**DEPARTMENT OF TRANSPORTATION - District 4 Toll Bridge Program**

Contract No. 04-0120E4  
04-SF-80-13.4, 13.8  
SAS T1 & E2 Foundations  
SFOBB-ESSSP

Subject: NCR - Oregon Iron Works, 02/27/06 (Welding Over Crack)

**Subject:** Oregon Iron Works Response to NCR Generated by State Letter 1070

QCMK-G-101-S-A1

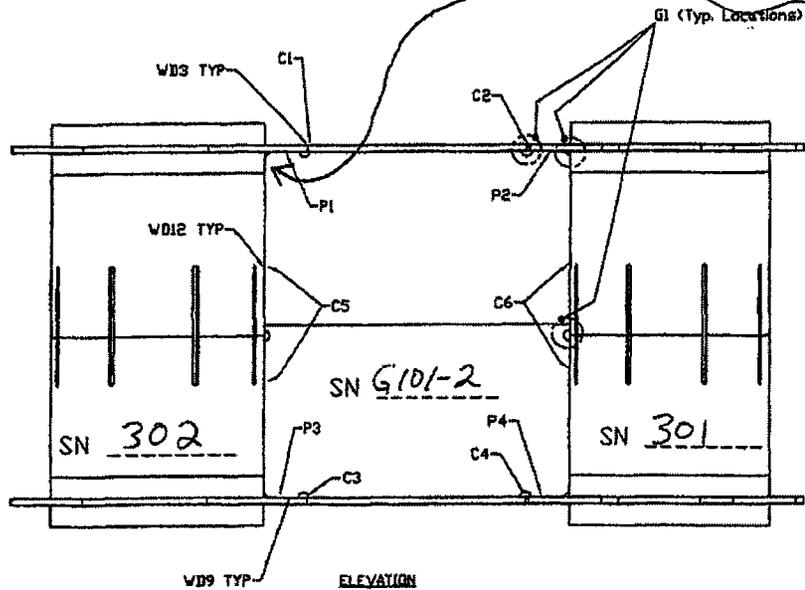
The Department issued a Non-conformance Report (NCR) at Oregon Iron Works in Vancouver, Washington, on February 27, 2006. The NCR was generated when QA observed OIW welding personnel welding over a crack at the toe of the weld joining girder web G101-2 to the pile sleeve PS302-1 of the Pier E2 footing. QA verbally notified Mr. Mike Gregson, OIW Quality Control Inspector, of this non-conformance on February 27, 2006.

\* Location of CRACK  
 33mm Long, 58mm Deep  
 START 38mm From Top of Weld  
 WJ C5

Check All Apply			Description of Condition
Receipt Insp.		Inspection Method	Weld crack 33mm L X 58mm D (WJ C5) Located 38mm from end of weld on web 103b to pile sleeve 501d
In Process Insp.		Visual	
Repair Insp.		Mag. Particle	
Base Material		Ultrasonic	
Weld Metal	√	Other	See Attached Drawing for Location
Following original excavation of a linear indication OIW production deposited approximately three passes on top of the linear indication to avoid blowing thru the weld joint.			
Production and QC have been counseled on the requirements of not welding over linear indications.			
OIW has addressed the root cause of the linear indication and have taken measures to increase preheat.

Check All Apply			Specific Instruction
Defect Removal Method		Post-Removal NDE	OIW proposes to excavate by scarfing back to the known depth of defect, remove defect by grinding and MT excavated area to verify complete removal of indication. OIW will then repair the area using WPS 3246. OIW QC will perform VT, MT and UT to verify weld soundness. QA shall be notified prior to performing excavation and welding.
Grinding	√	Visual	
Carbon /Air Arc	√	Mag. Particle	
Other		Ultrasonic	
		Other	
Additional Notes / Comments:

QCMK-G-101-S-A1

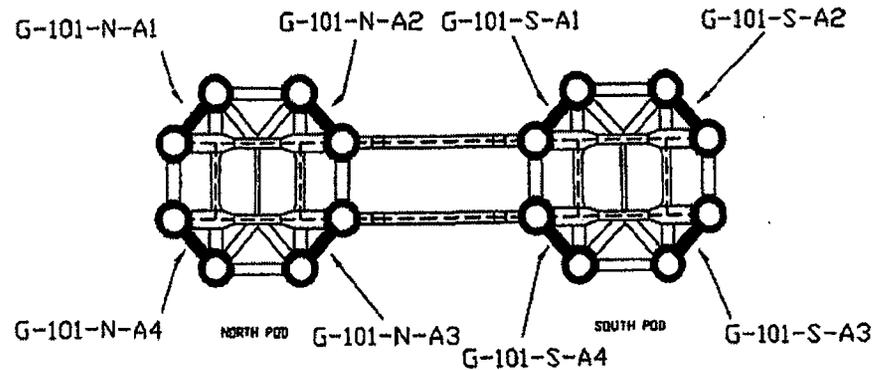
\* LOCATION OF CRACK  
 33mm Long, 58mm Deep  
 START 38mm From Top of Weld  
 WJ C5

Check All Apply			Description of Condition
Receipt Insp.		Inspection Method	After the affected area was repaired following the specific instruction in CWR# 2083-016, UT inspection revealed a rejectable indication.  See Attached Drawing for Location
In Process Insp.		Visual	
Repair Insp.	✓	Mag.Particle	
Base Material		Ultrasonic	
Weld Metal		Other

Check All Apply			Specific Instruction
Defect Removal Method		Post-Removal NDE	OIW proposes to excavate by scarfing back to the known depth of defect, remove defect by grinding and MT excavated area to verify complete removal of indication. OIW will then repair the area using WPS 3246. OIW QC will perform VT, MT and UT to verify weld soundness. QA shall be notified prior to performing excavation and welding.
Grinding	✓	Visual	
Carbon /Air Arc	✓	Mag.Particle	
Other		Ultrasonic	
Additional Notes / Comments:
